Bartley Square

Project Review for Planning and Zoning Commission

<u>Meeting Date:</u>	June 20, 2012
<u>Request:</u>	Conceptual PUD review for two-40 unit apartment buildings and an approximately 12,000 square foot retail development.
<u>Location:</u>	SWC of Bard Road and Huntley Road
<u>Acreage:</u>	Approximately 6.8 acres
<u>Existing Zoning:</u>	“B-1 PUD” Neighborhood Commercial PUD and “R-3B PUD” Multi-Family PUD
<u>Surrounding Properties:</u>	North: “R-2” Single-family residential South: “R-1 PUD” Single-family PUD (<i>Harvest Run</i>) East: “R-1 PUD” Single-family PUD (<i>Wedgewood</i>) West: “E” Estate (<i>City Fire Station/ Water Tower</i>) “R-3B PUD” Multi-Family PUD (<i>Walnut Glen</i>)
<u>Staff Contact:</u>	Latika Bhide (815.356.3615)

1 PRELIMINARY SITE PLAN
SCALE: 1" = 40' 0"

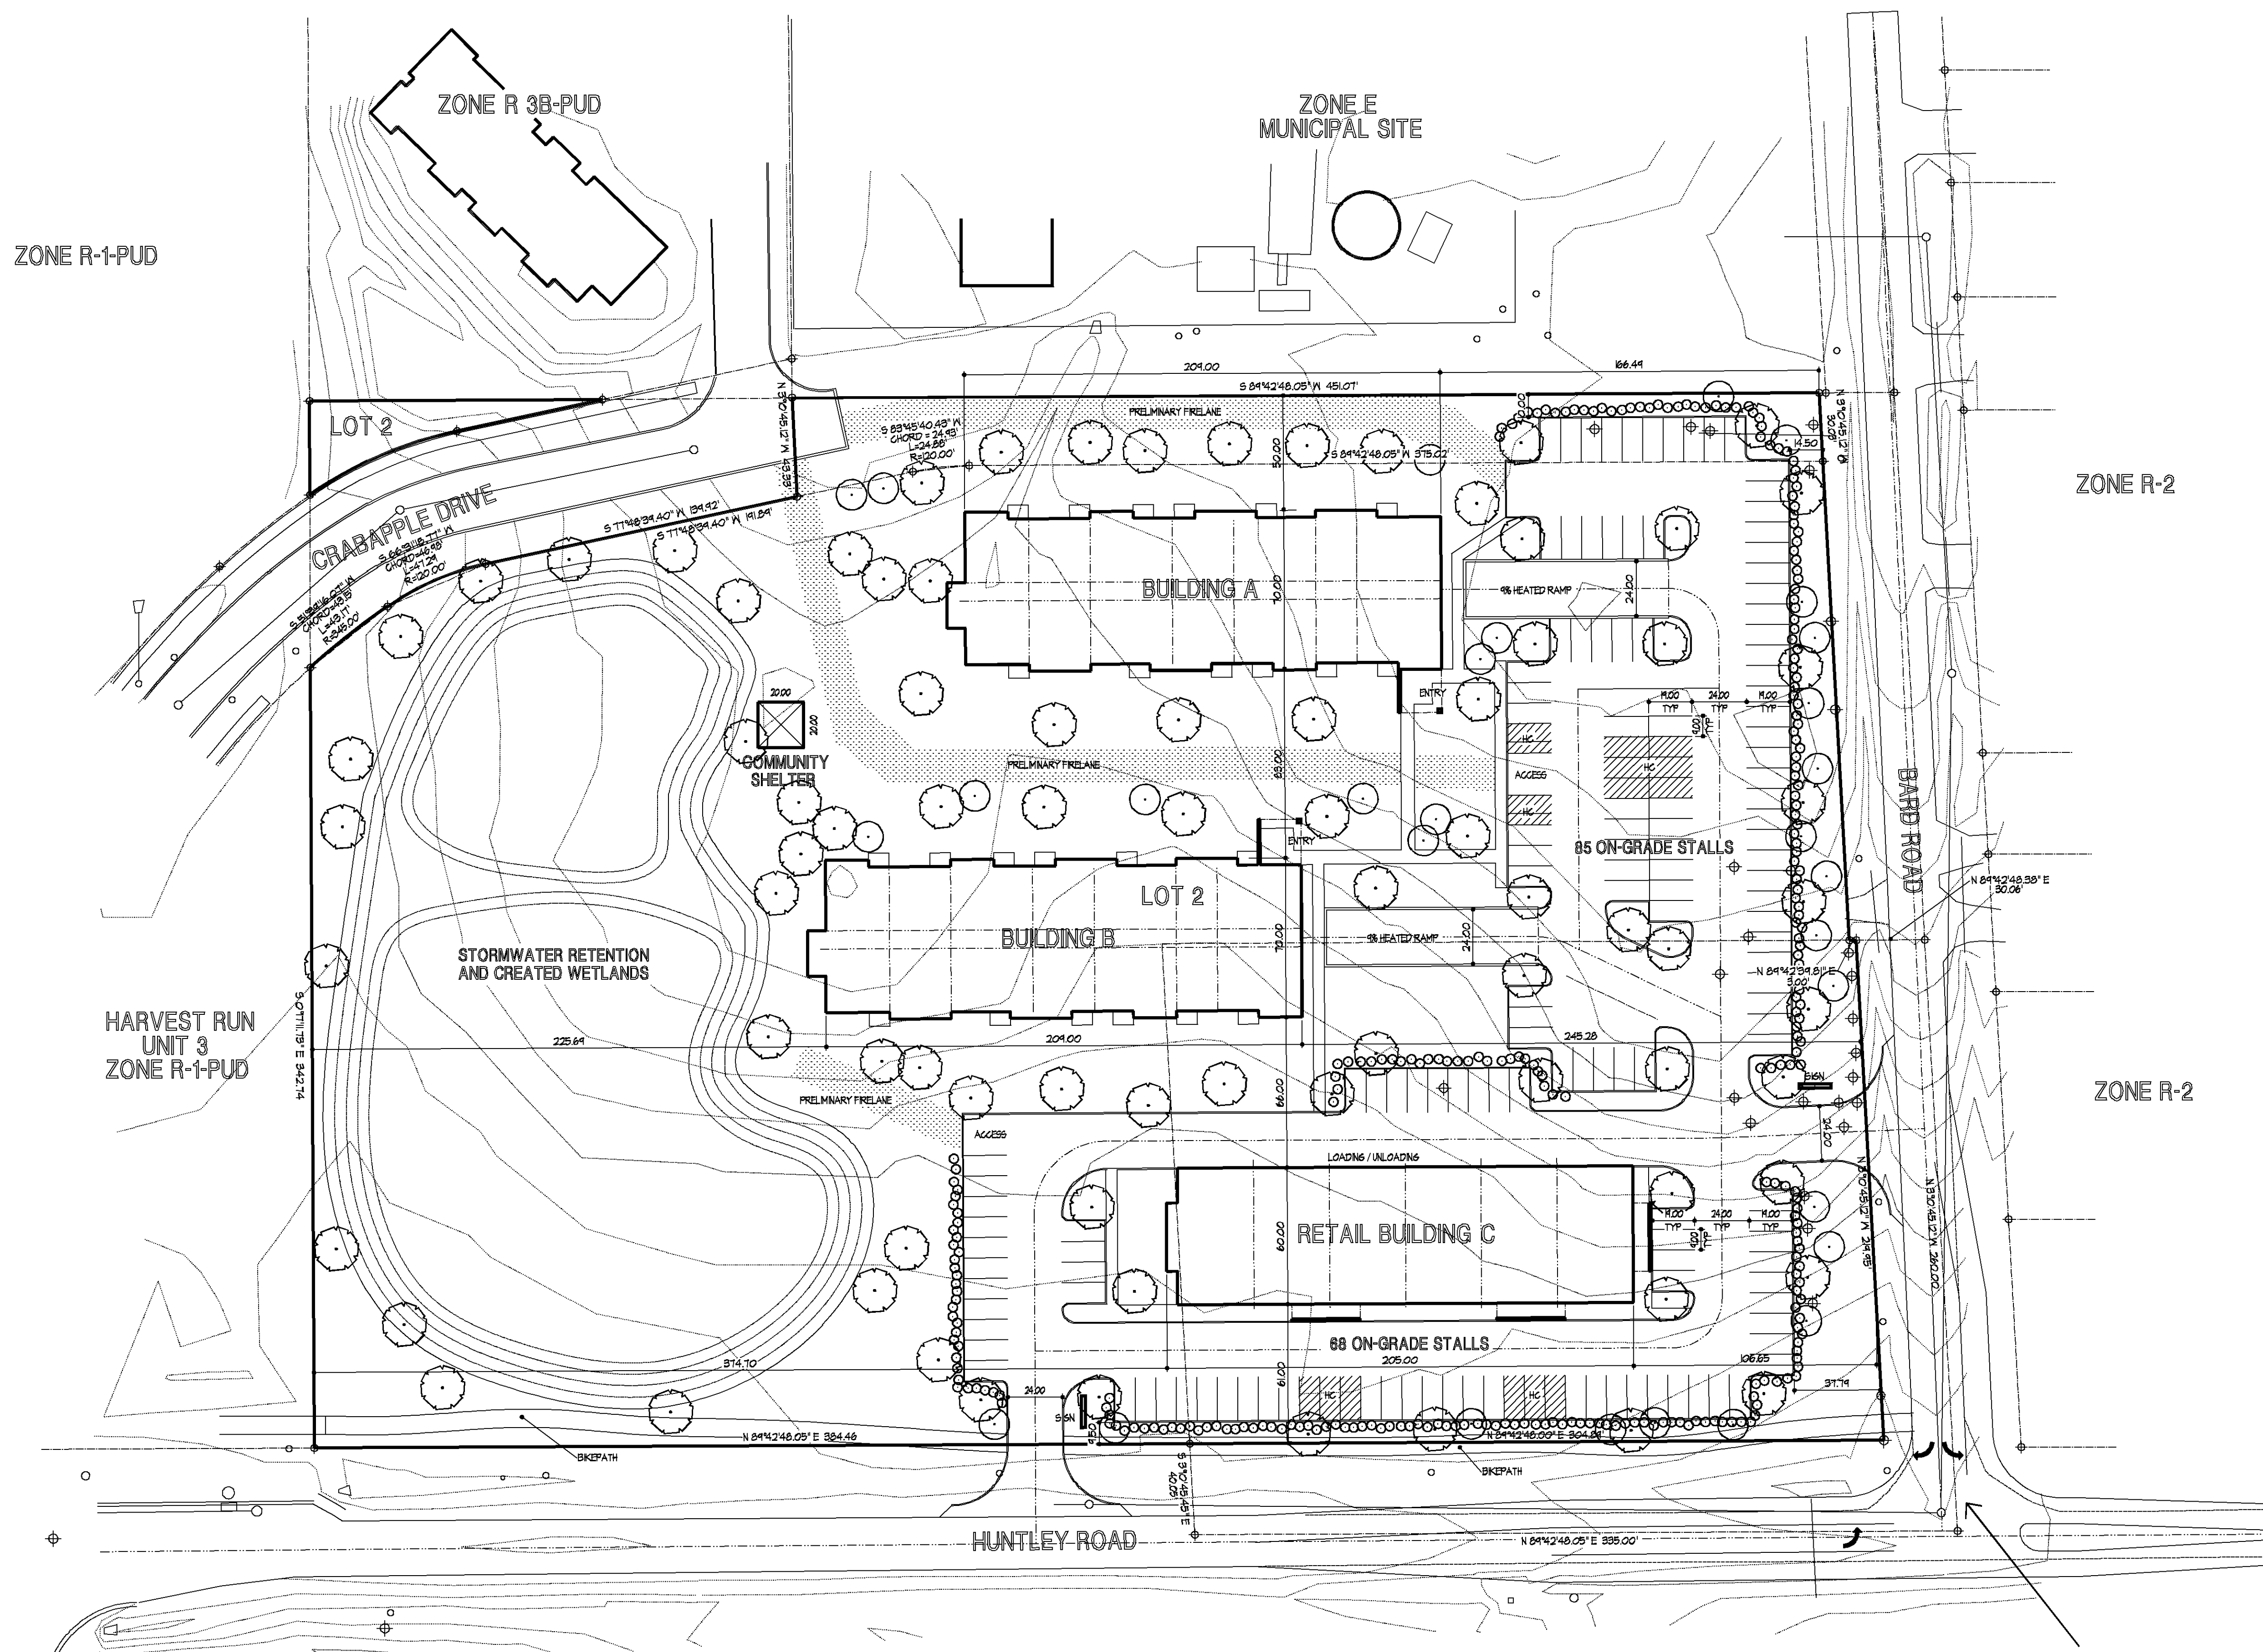
- ❑ The site plan proposes two-40 unit apartment buildings, 3 stories high, sited in the east-west direction, located closer to Bard and Huntley Roads.
- ❑ Two access points into the development are proposed, one off Bard and Huntley Roads, consistent with earlier approval.
- ❑ The portion of the site closest to the adjoining residential development (Harvest Run) is proposed to be stormwater retention and created wetlands.

- ❑ Bulk of the parking requirement (88 spaces) for the apartment buildings is provided via underground parking beneath both buildings. 69 surface parking spaces are also provided for the residential component. Based on the conceptual unit configuration, it appears that adequate parking, including guest parking is propose,
- ❑ Surface parking is proposed for the inline-retail portion of the development.

It should be noted that the petitioner will be required to update the traffic study that was completed for the previous development. Based on the conceptual plan provided, the petitioner is seeking initial comments on the overall concept of their development.

1. Is this site appropriate for this type of development?
2. What are the Commission's thoughts about the proposed site layout?
3. It appears that a density bonus would need to be granted. The City's UDO outlines three processes for receiving a density bonus:
 - i. Through the PUD process where bonuses may be granted for encouraging high quality design and environmentally sensitive development, superior design or the provision of additional amenities such as public open space.
 - ii. Through the Inclusionary Zoning provision, where bonuses can be granted when at least 10% of the total number of units proposed and not more than 30% of the total number of units proposed for a project are Inclusionary Dwelling Units.
 - iii. Through the Transfer of Development Rights (TDR) process where a TDR agreement has been presented to the City.
